NUMBER: 09-011-15

Incorrect 6.4L Engine Oil Dipstick

2015 (WK) Jeep Grand Cherokee

Fig. 1 Location Of The Part Number On The Dipstick

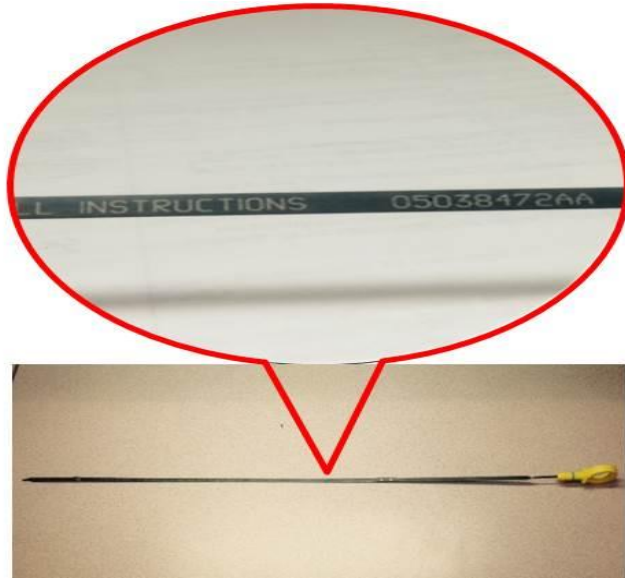
1. Remove the Dipstick from the tube and look for the part number.

-
2. Is part number 05038472**AA** on the Dipstick?
 - a. Yes >>> Replace the Dipstick with part number 05038472**AB**.
 - b. No >>> This bulletin does not pertain, perform normal diagnostics if needed.
